## Workman® Sprayer Sonic Boom

**Subject:** Change to Sonic Boom Wire Harness.

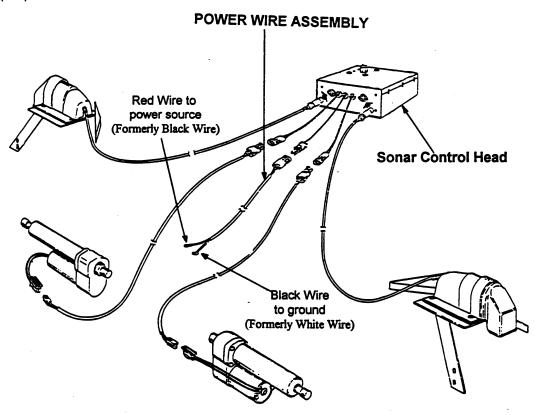
The colors of the Power Assembly leads changed during the 1993 model year. Originally, the power wire assembly used a Black wire and a White wire. The wires were routed as follows:

Black Wire: To the Power Source

White Wire: To Ground

The power wire assembly currently uses a Red wire and a Black wire. The NEW wires are routed as follows:

Red Wire: To the Power Source

Black Wire: To Ground

All current manuals for the 1993 model year are correct in showing the new Red/Black power wire assembly. The power wires regardless of the color of the harness are tagged with an "+" or "-" to ensure proper installation. See illustration below.
